FCT SERVICE NOTE

SN05080916a

Power cable (2363839-2) for slip ring transmitter may not have (Fair-rite) ferrite bead positioned or secured properly.

HP60, HP100 & RT systems manufactured in Waukesha from approximately January 2005 to present.

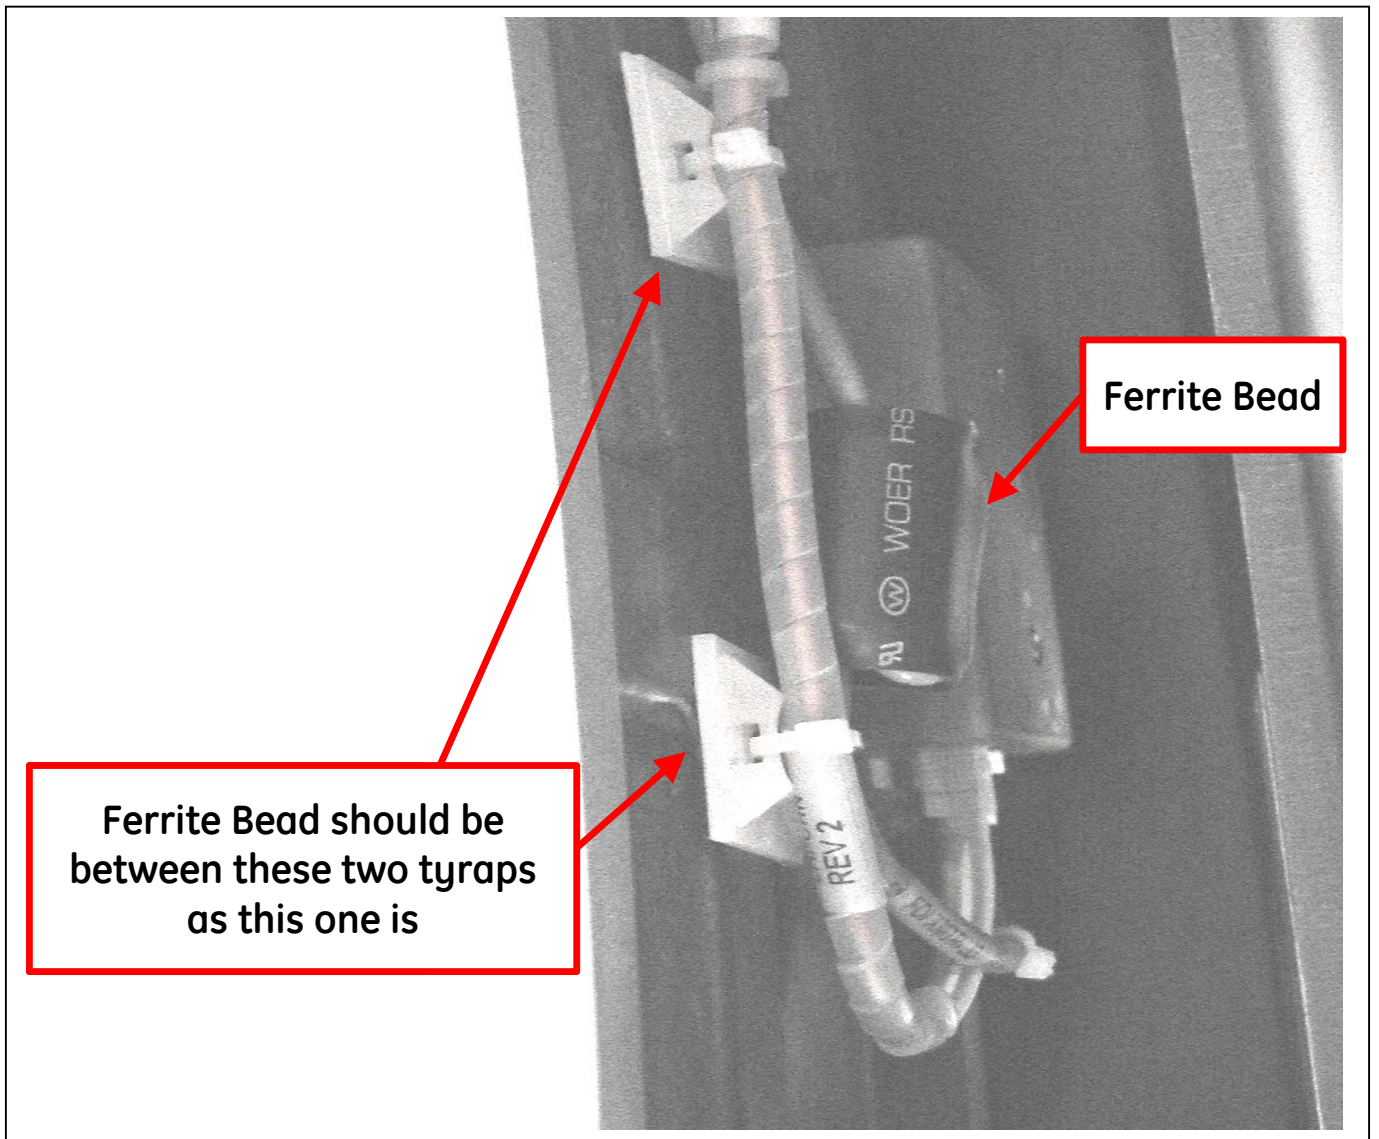
The ferrite bead moves around when it is not secured properly. The cable becomes disconnected and cable damage may occur.

The transmitter is located on the slip ring and directly below it are 2 ty-wrap pads.

The ferrite bead should be ty- wrapped between these pads.

Inspect ferrite bead position. Remove right gantry side cover. Turn off axial drive & HV enable switch. Rotate gantry so that the center das chassis is approximately at the 1 o'clock position. You now should be able to see the transmitter though the opening in the upper slip ring cover. The opening in the cover is by the receiver.
